SIGAR 20-21 Inspection Report

Kajaki Dam Irrigation Tunnel: The \$27.3 Million Tunnel Is Not Operating Properly Due to Construction Deficiencies and a Maintenance Issue

**JANUARY
2020**

Figure 1 - Cross Sectional Schematic View of the Kajaki Dam Irrigation Tunnel

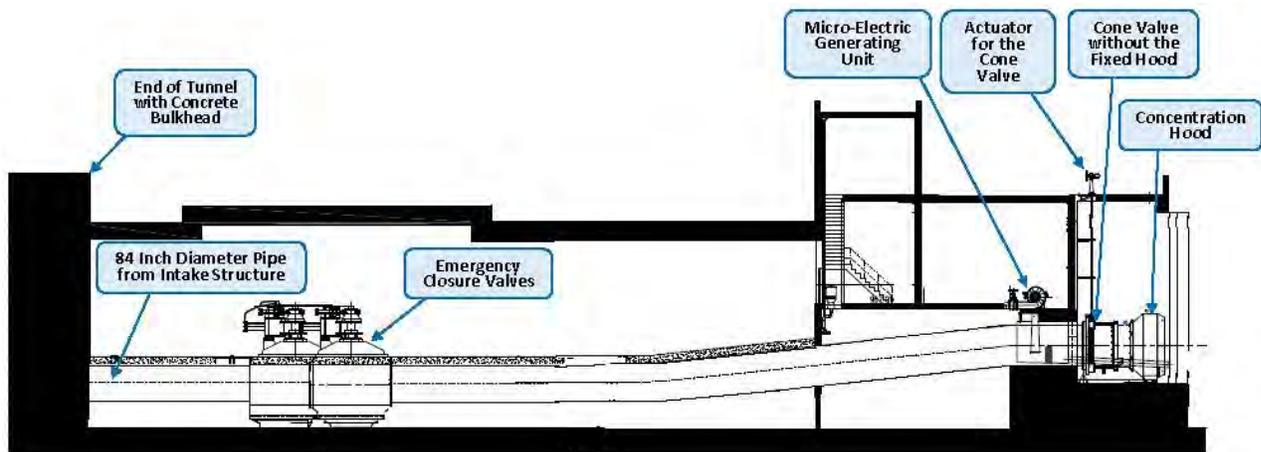
On January 30, 2013, the U.S. Army Corps of Engineers (USACE) awarded a \$25.6 million firm-fixed-price contract to Metag Insaat Ticaret A.S. (METAG), a Turkish firm, to repair the irrigation tunnel's intake structure, refurbish the emergency closure valve, replace the cone valve, and replace the micro-electric generating unit (see figure 1).²
